Sunfield Fast-track

Auckland Council Specialist Memo

Healthy Waters and Flood Resilience Memo

4 August 2025

Figure 1. Catchments

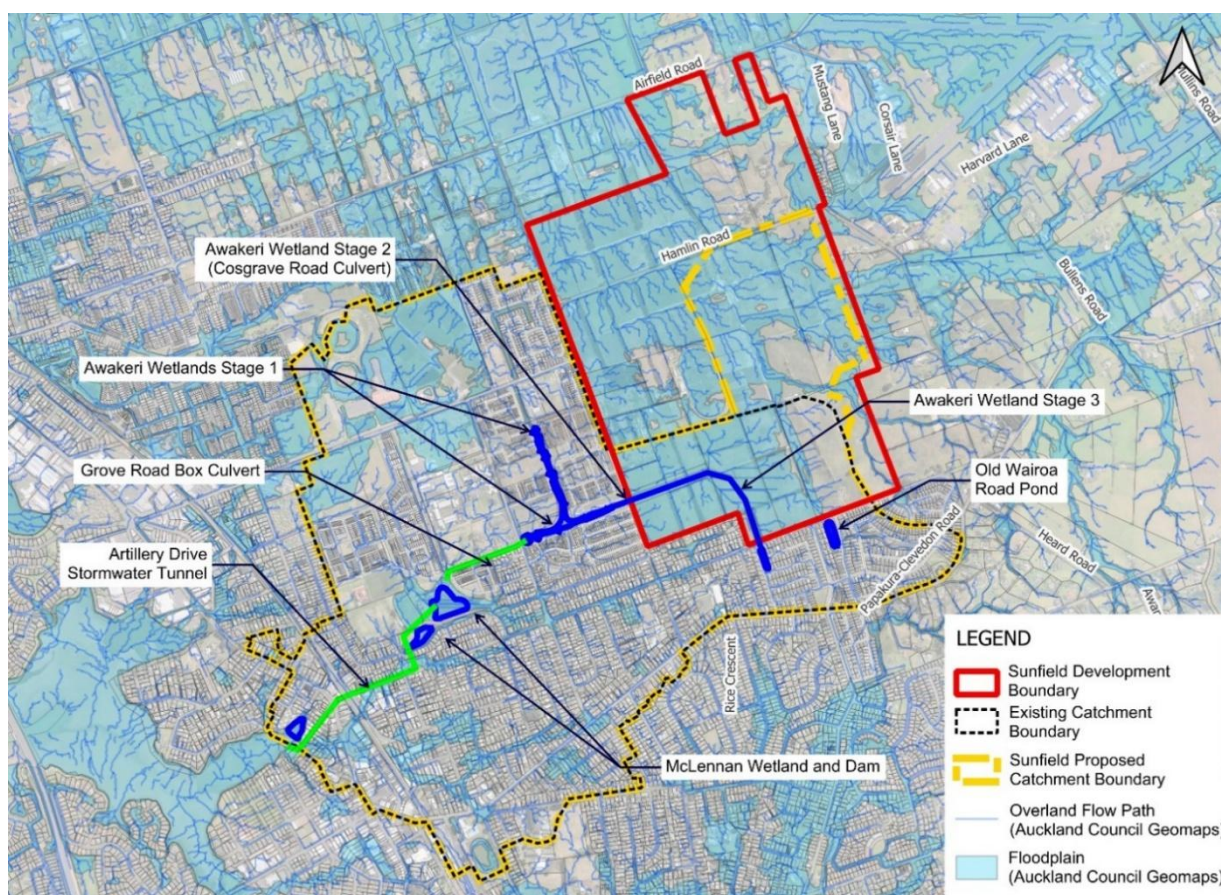
- 1.7 To mitigate the effects of increased flooding caused by the proposed development, the Application proposes a complex scheme of stormwater attenuation ponds and catchment diversions. This includes diverting approximately 54.9 hectares of catchment from the Papakura Stream catchment to the Pahurehure Inlet catchment, as shown in Figure 1.

Figure 4. Sunfield development site (red) underlain by Auckland Council Geomaps OLFP, Flood-Prone and Floodplain layers

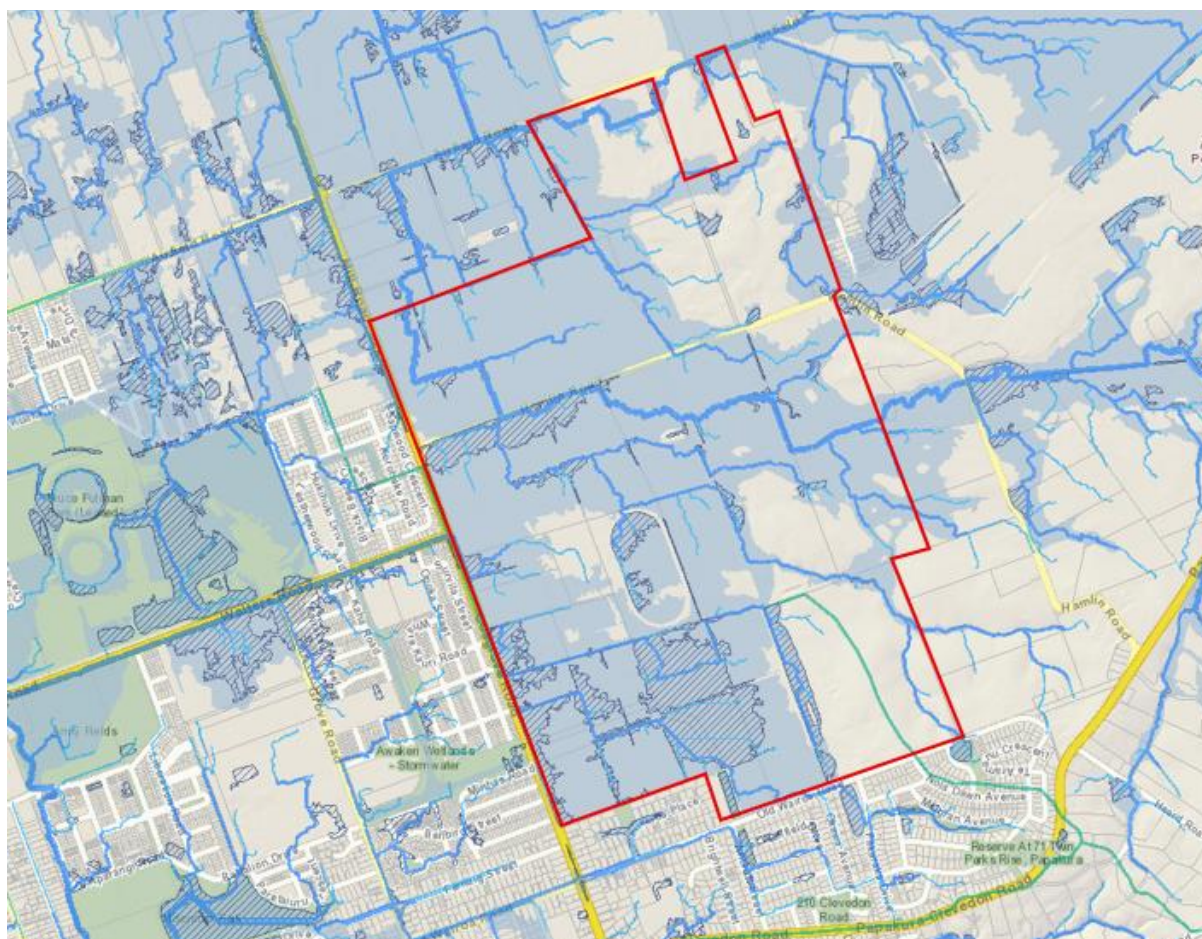
- 3.4. The site and its surrounds are subject to significant flood hazards. Approximately 80% of the site is within the 1% Annual Exceedance Probability (**AEP**) flood plain (Figure 4). Flood depths are generally 200mm to 800mm deep across the site during this storm event.

Figure 8. Profile through the site showing proposed earthworks topography (orange line), compared to existing (green dash), the blue line shows the measured groundwater levels.

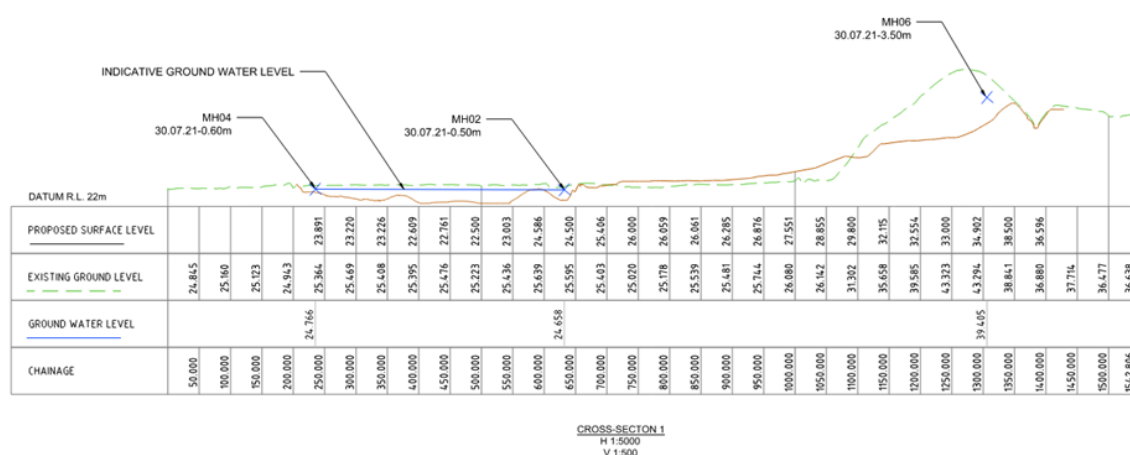
3.39. Both the Infrastructure Design Report and the Geotechnical Design Report are ambiguous as to how groundwater will be managed in relation to the ponds and conveyance channels, noting that they are currently shown to be cut to below existing groundwater levels measured and observed across the site. However, the stability analysis included in the Geotechnical Assessment Report appendices appears to be based on the assumption that the groundwater level will be lowered to the permanent long term, low water level in the channel. This approach will require careful consideration of the area affected by this drawdown and the implications of settlement effects on the proposed development and associated infrastructure. As shown in Figure 8, within the basins and channels, earthworks are proposed well below the existing groundwater table.

Figure 2-8: Snip from M-C4602, reproduced from applicant's lodged document. Box culvert location shown.

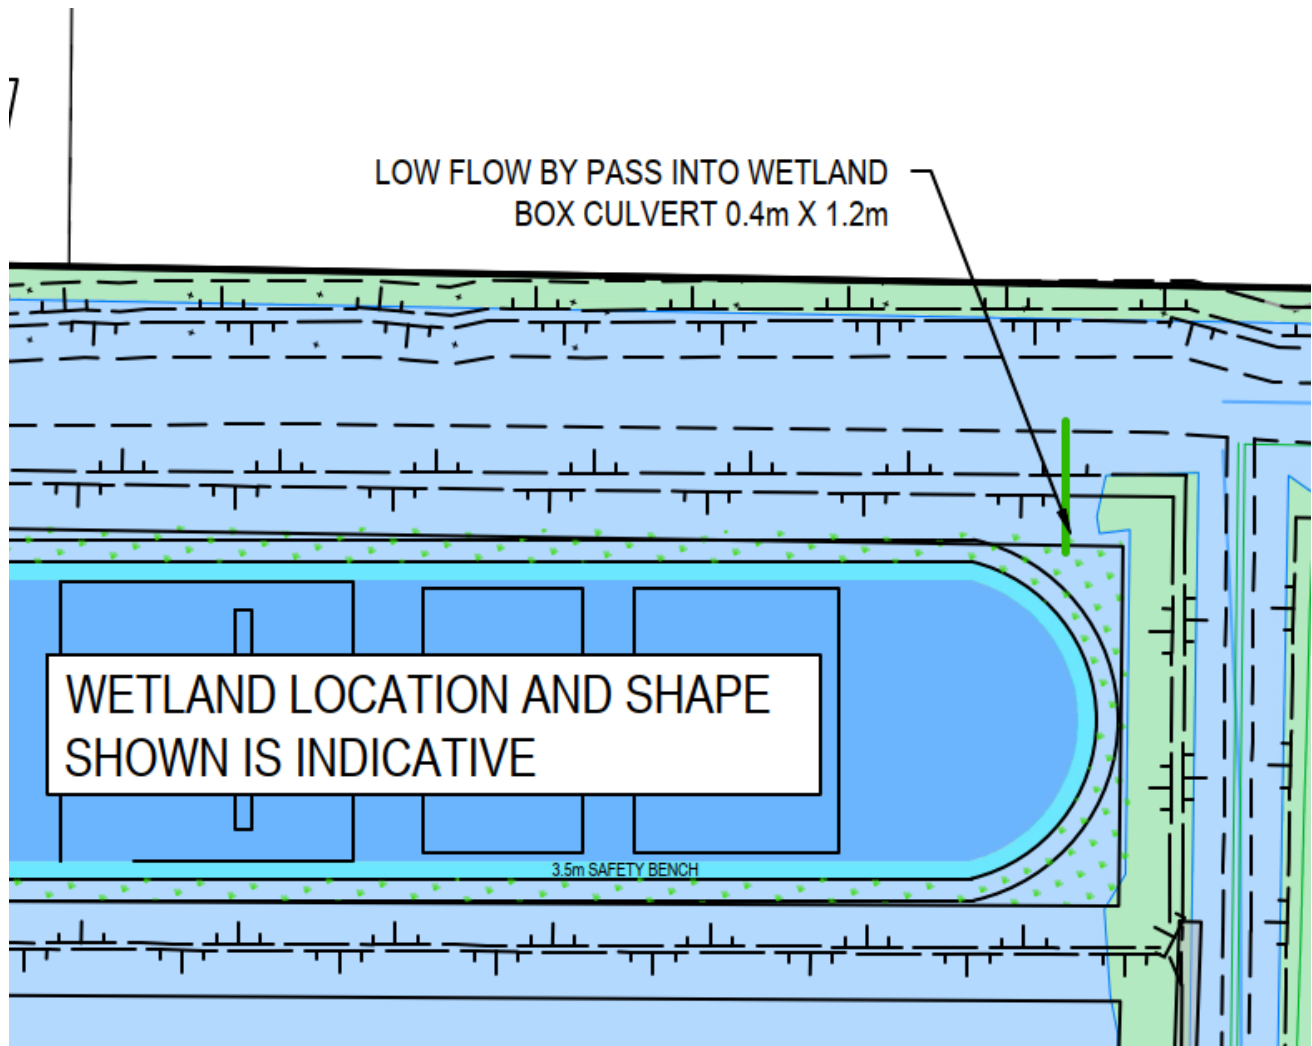
The drawing M-C4602 shows a box culvert connecting the diversion channel to the 10-year ARI basin of pond 1, as shown in Figure 2-8. The drawing does not show the invert of this box culvert, and no further information is provided. We have therefore assumed that this is an open culvert (no flap gates) at the invert level of the pond.

Figure 2-10: Pond 1 Outfall weir profile.

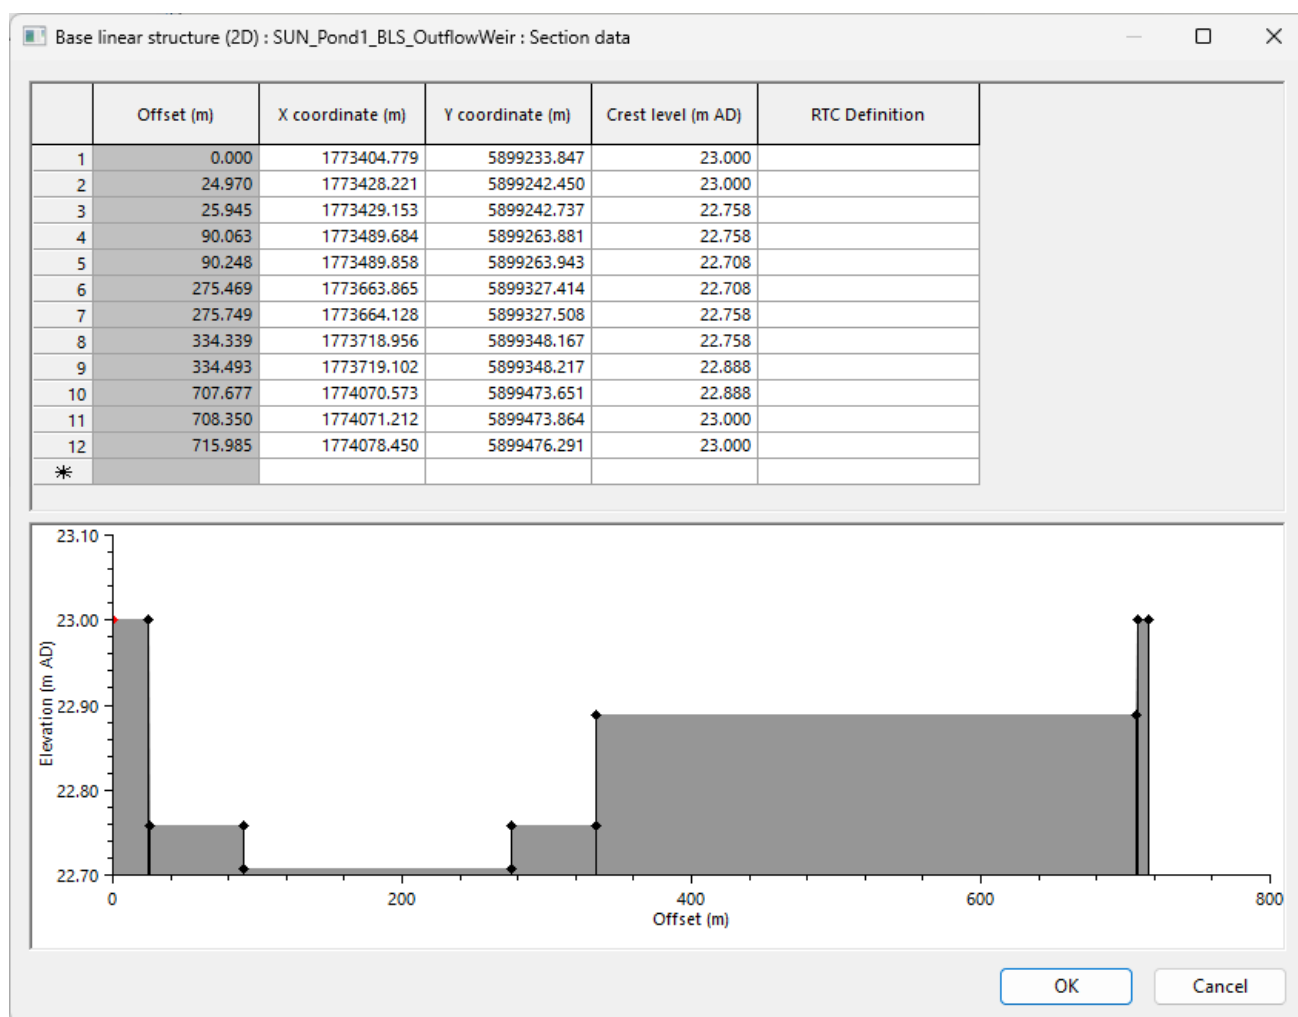
The outflow weir has a varying crest height, as shown in Figure 2-10.

Note a label on M-C4605 drawings states that the 22.47m AD (NZVD2016) section of bund is 20m long, however the geometry length is close to 60m long. This difference results in a significant change in the performance of the bund. We have assumed that the geometry is correct, and that the label is wrong. This is shown as the second section of 22.758m AD (AUK46) weir in Figure 2-10.

Figure 6-1: Example of existing overland flow paths through the Sunfield development site – 2-year ARI CN61 E.

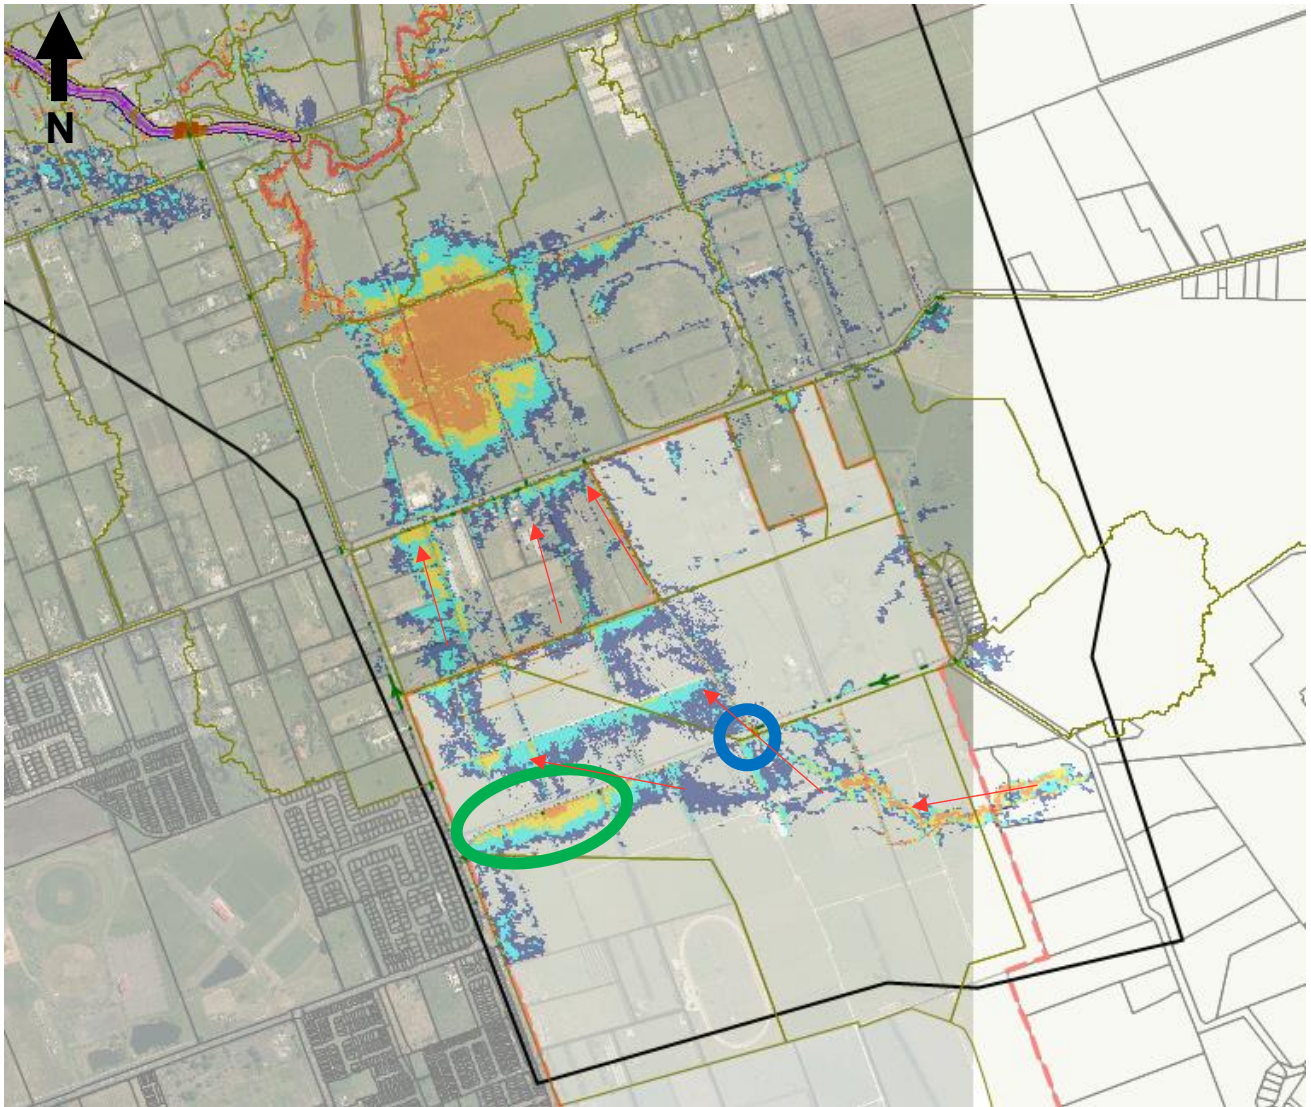
The Sunfield development (as per the provided drawings) will remove existing overland flow paths that currently flow through the site. The existing flow path shown in Figure 6-2.

- Main flow path under a bridge near 51 Hamlin Road (Blue circle in Figure 6-1).
- Hamlin Road retains some runoff, with flows eventually spilling over at the western end of Hamlin Road (Green circle in Figure 6-1)

Current flows out of the Sunfield site are spread across multiple properties, as shown with red arrows.

Figure 6-2: Proposed overland flow path through Sunfield development site – 2-year CN61 E+SUN.

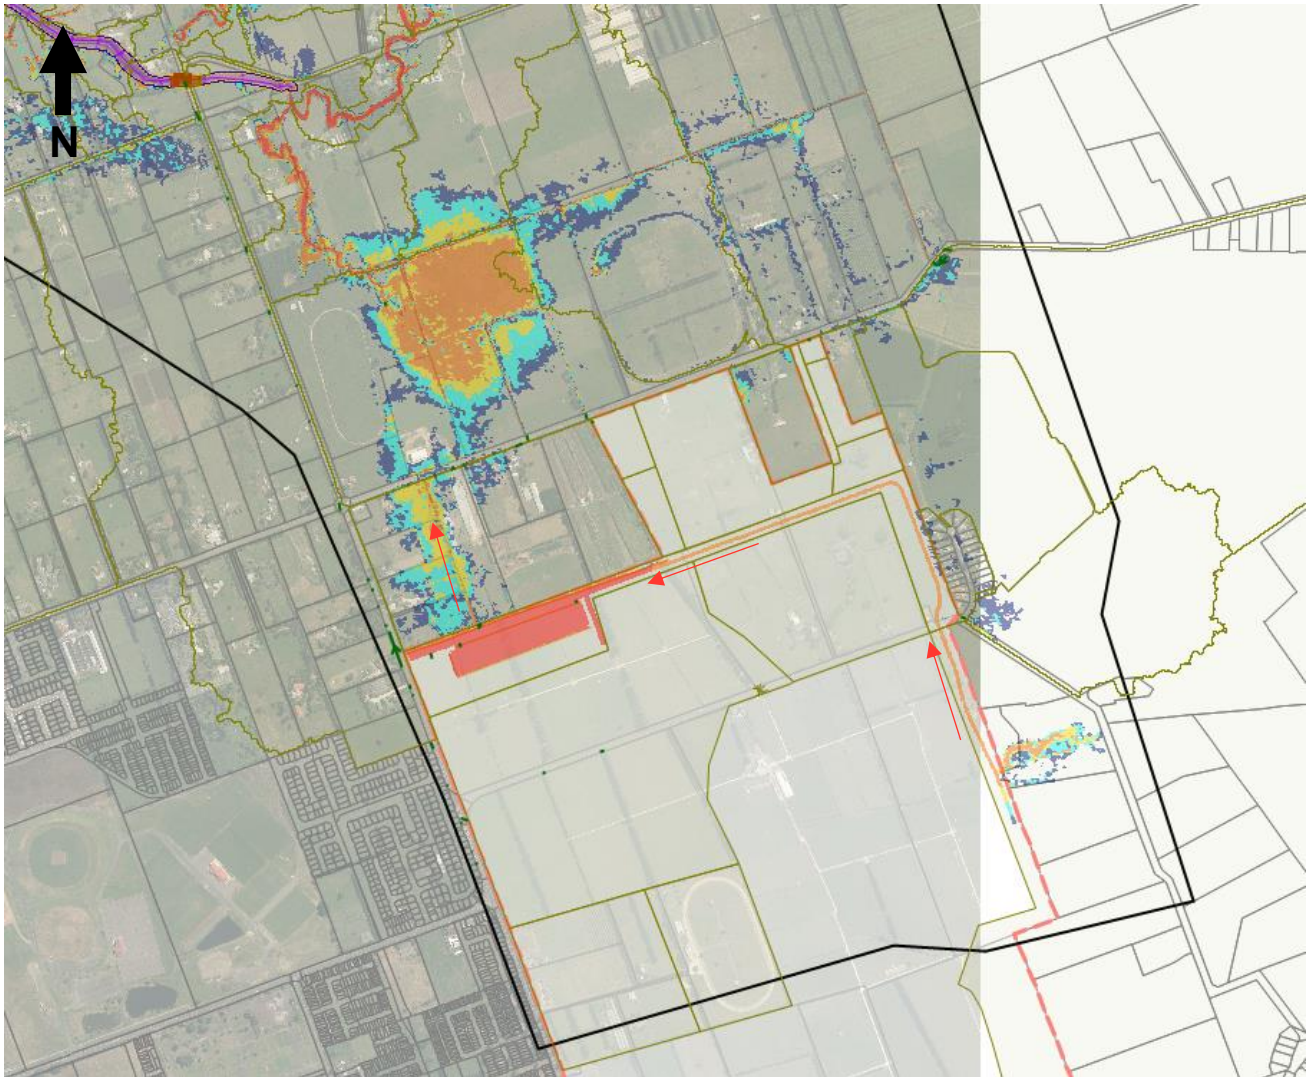
The applicant proposes to collect and discharge all the upstream rural flows through the diversion channel into pond 1. This will concentrate the current overland flow paths and discharge them all into private property at one location.

Figure 6-3: Change in predicted peak flood depth in the 2-year ARI, CN61 scenario, showing increase in predicted flood depth downstream of Pond 1.

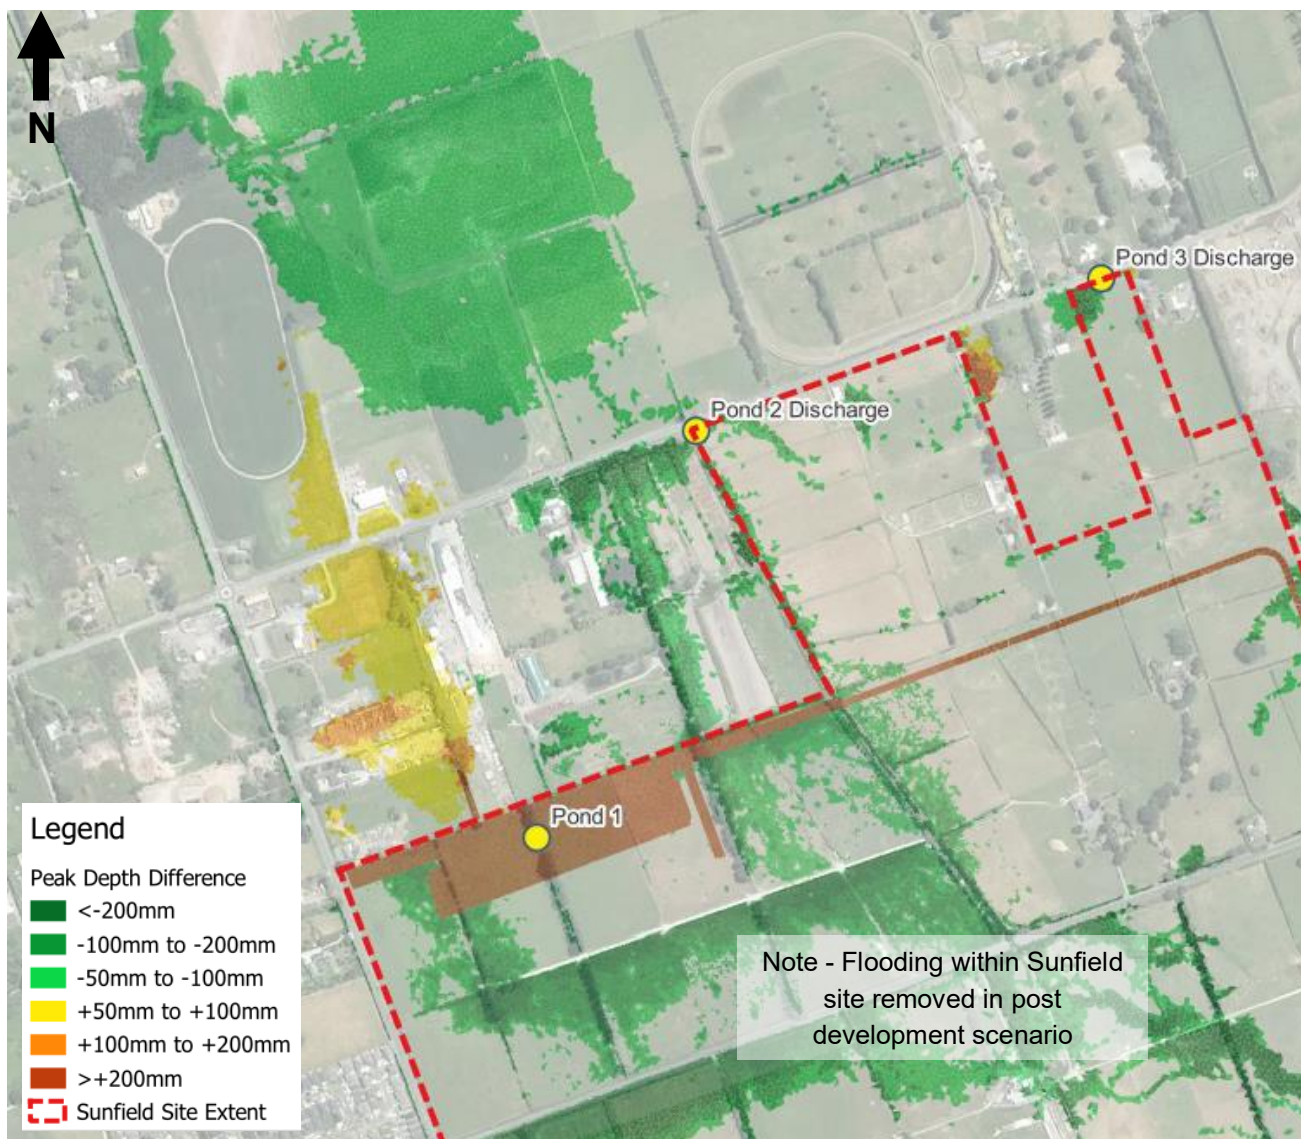
In some scenarios the increase in flood depth is greater than 100mm, and increases the predicted flood hazard to properties downstream. In the 2-year ARI CN61 scenario there is an increase in flood depth of greater than 100 mm downstream of the pond 1 outfall, as shown in Figure 6-3.
